Access Compliance Report

Public Rights-of-Way

(Curb Ramps)

Intersection ID: 10033787	Main Street: PACIFIC_ECHO_DR	Cross Street: N/A	Location: SE
ADA ID: E952DB240216	Ramp Type: Perp	Initial Pass/Fail: Fail	Overall Compliance: No
Severity Score: 12.5			
Codes/Mitigation Info/Possible Solution		Field Measurements/Component Compliance

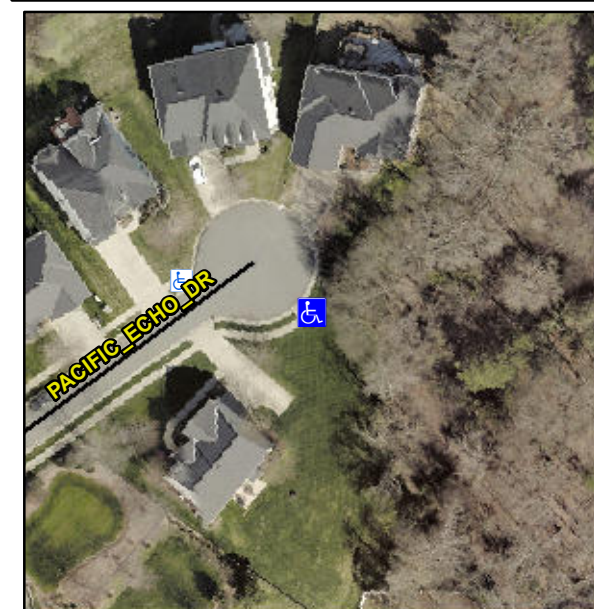
Not Found, R304.2.2

Compliance	Description	Data	Compliance	Description	Data
N/A	Ramp Length (in)	47.0	No	Ramp Slope (%)	8.9
Yes	Ramp Width (in)	59.0	Yes	Ramp XSlope (%)	1.9
N/A	Flare Type LT	N/A	N/A	Flare Type RT	N/A
N/A	Flare Slope LT (%)	N/A	N/A	Flare Slope RT (%)	N/A
N/A	Flare Traversable LT?	N/A	N/A	Flare Traversable RT?	N/A
N/A	Landing Length (in)	N/A	N/A	DWS Provided?	N/A
N/A	Landing Width (in)	N/A	N/A	DWS Contrast?	N/A
N/A	Landing Slope (%)	N/A	N/A	DWS Length (in)	N/A
N/A	Landing X Slope (%)	N/A	N/A	DWS Full Width?	N/A
N/A	Landing Curb? (Y/N)	N/A	N/A	DWS Offset (in)	N/A
N/A	Shared Landing?	N/A			
N/A	Gutter Ponding?	N/A	N/A	Gutter Slope (%)	N/A
N/A	Gutter Lip Ht (in)	N/A	N/A	Gutter X Slope (%)	N/A
N/A	Painted X Walk1?	No	N/A	Painted X Walk2?	N/A
	X Walk 1 Direction	To NW		X Walk 2 Direction	N/A
N/A	X Walk 1 Width (in)	N/A	N/A	X Walk 2 Width (in)	N/A
	X Walk 1 Slope (%)	3.8		X Walk 2 Slope (%)	N/A
	X Walk 1 X Slope (%)	1.2		X Walk 2 X Slope (%)	N/A

Remove & Replace Entire Ramp.
